Technical Bulletin

Ref: **TB-18002-ENG**

Subject: Oxygen sensor part number change

New Oxygen Sensor	Preparation Instructions and Installation	Image of Sensor
80890 (Envitec)	After removing the sensor from the package. Insert the sensor, contact-end first, into the device.

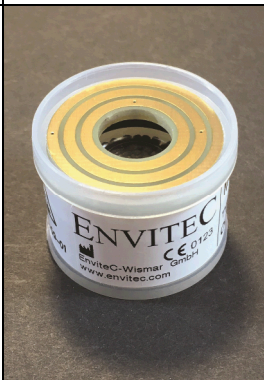
Replacement Part	Previous Part Number	New Part Number
Sensor, O ₂	80043 (Discontinued)	80890

Note: The new oxygen sensor **DOES NOT** have a shorting button attached to the replacement sensor.
